ADDENDUM NO. 07
June 8, 2010

Project: **ALLIED HEALTH ADDITION @ CENTRAL CAMPUS**
San Jacinto College District

Bay Project No.: **0822**

ADD-7-SKM1

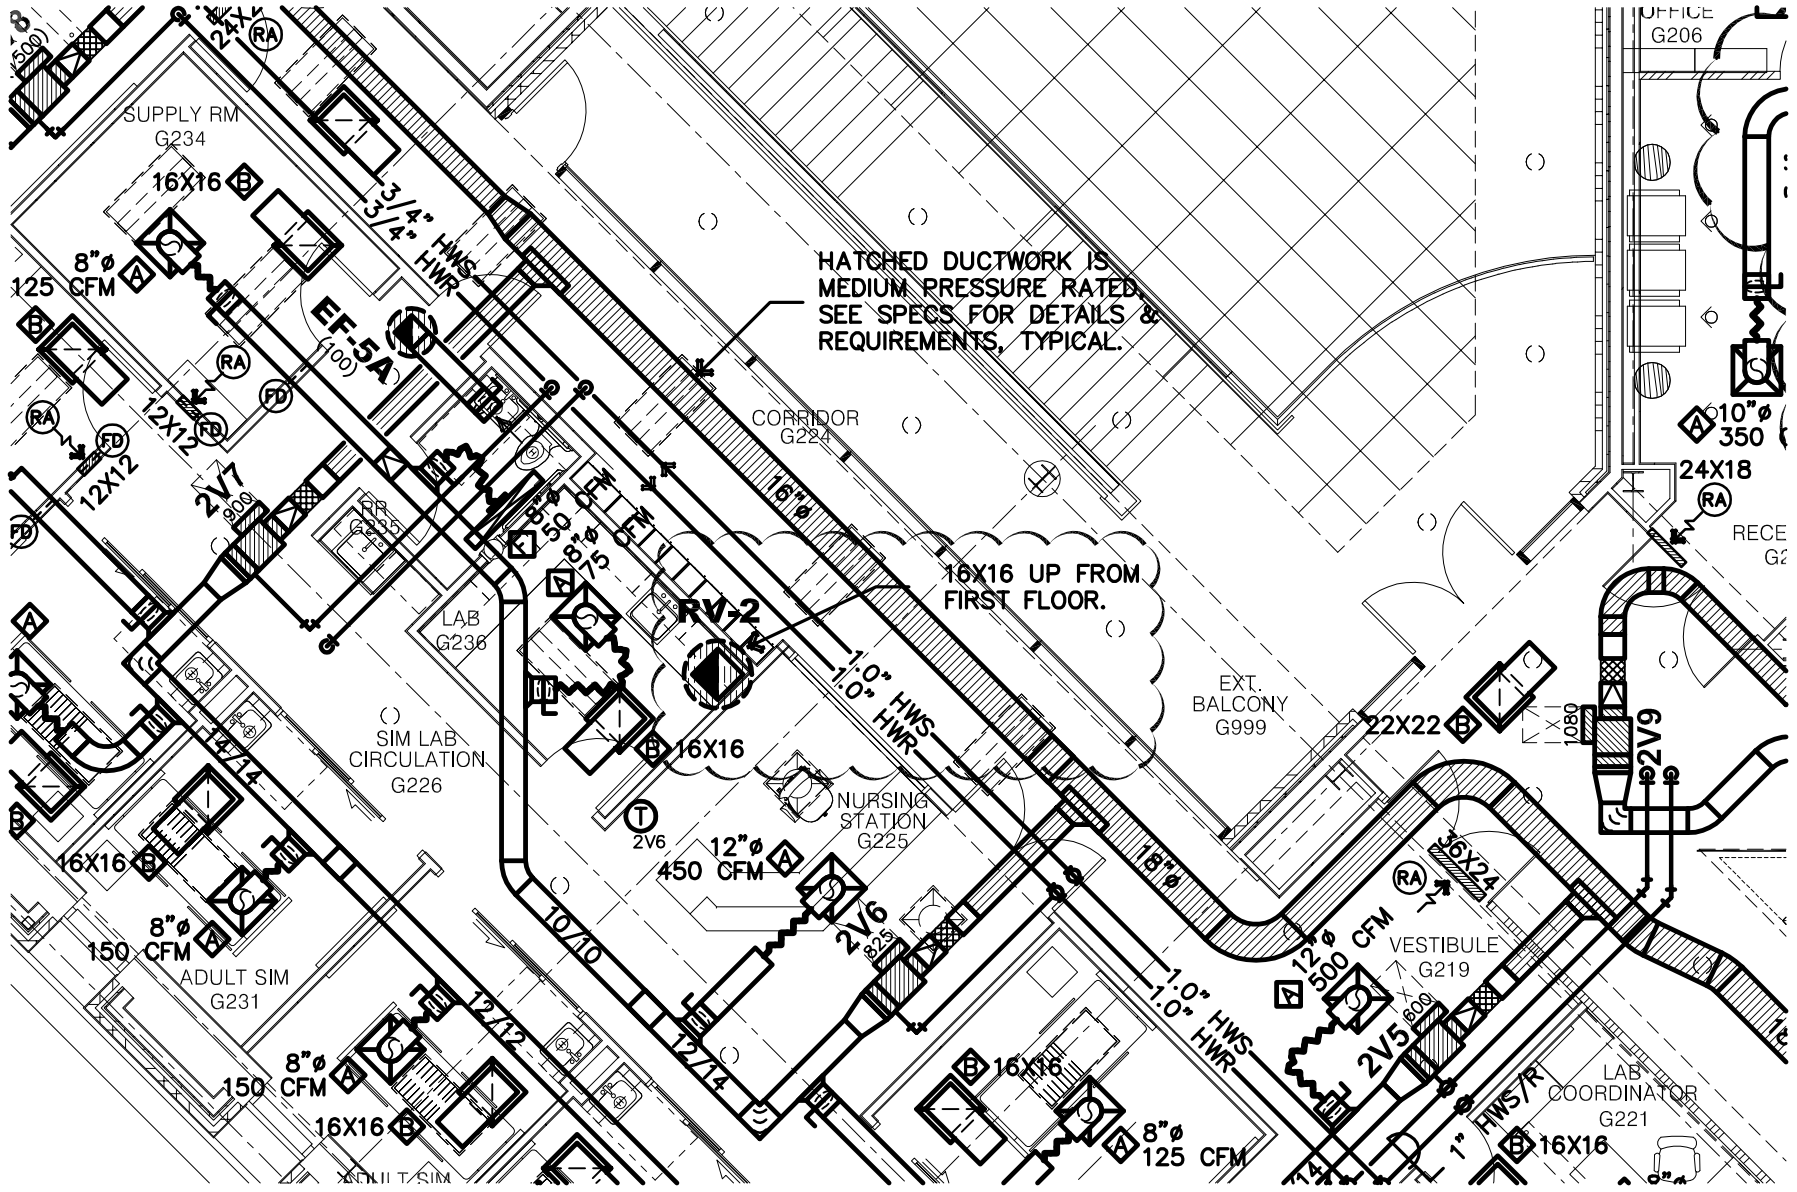
14. Sheet M1.01 – Mechanical Floor Plan – 1st Floor Areas E & F
 - a. Revise MM-A ductwork per the attached Drawing ADD-7-SKM1.

ADD-07-SKE1

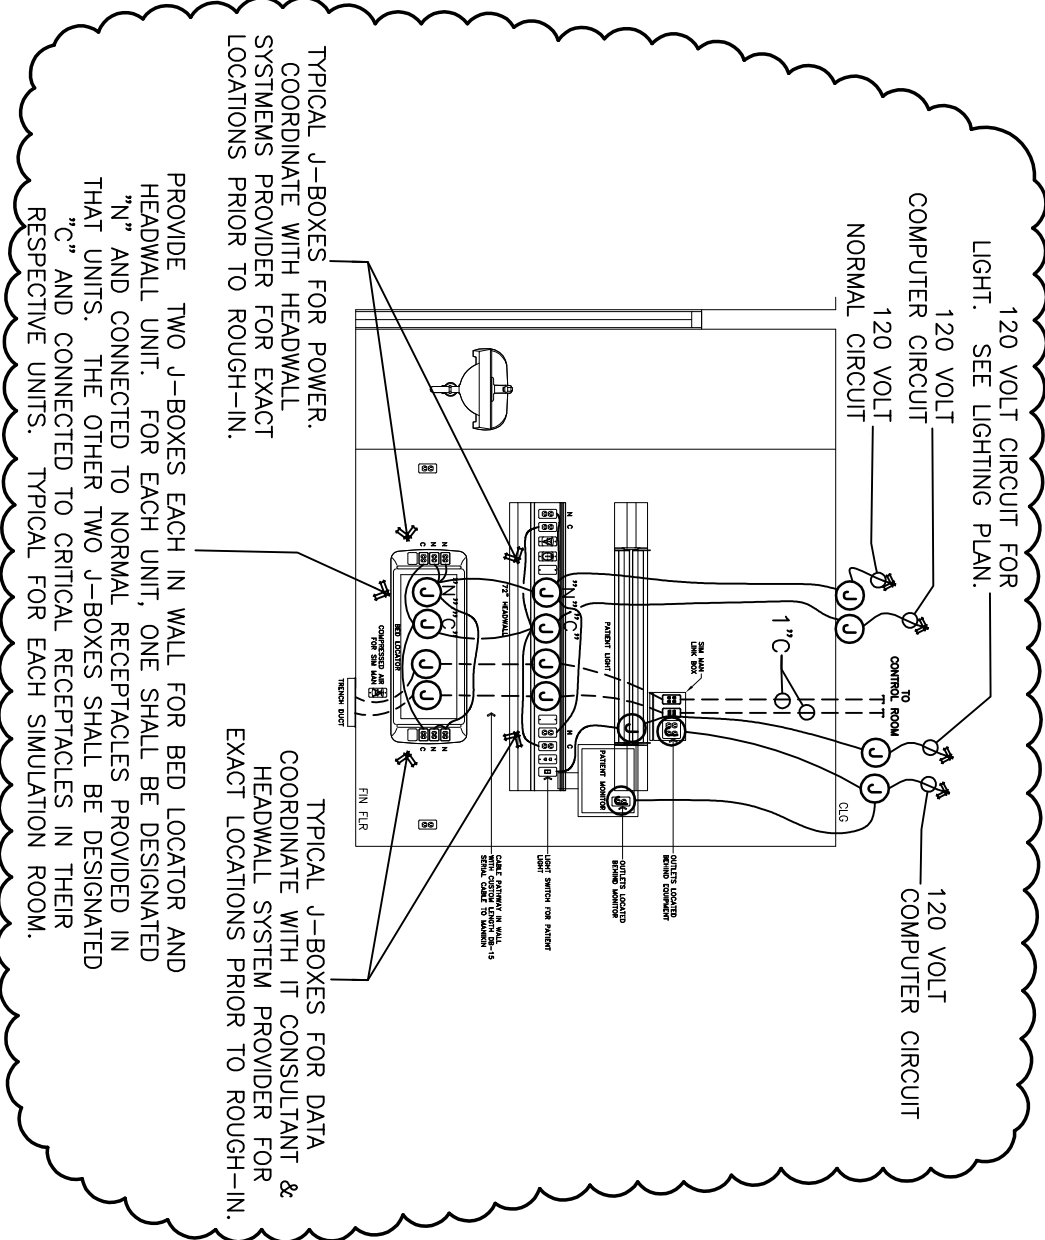
17. Sheet E1.04 – Electrical Power Plan – 2nd Floor Areas G & H
 a. Simulation Lab Rooms G227, G228, G229, G230, G231 and G232:
 1) Add Detail 2/E1.04 titled “Typical Sim Room Headwall Electrical Plan”. see attached **DRAWING ADD-07-SKE1**.

2) Add the phrase “See Detail 2 this drawing for additional detail” to the notes pointing to these junction boxes at three different locations.
 3) Add one duplex computer receptacle located just off the right end of the patient light unit of the headwall system to serve the monitor.. Connect to existing computer circuits. Also, revise the mounting height of one of the quad receptacles to serve the sim link equipment. Coordinate with headwall unit provider prior to rough-in. Typical of each of the six simulation rooms.
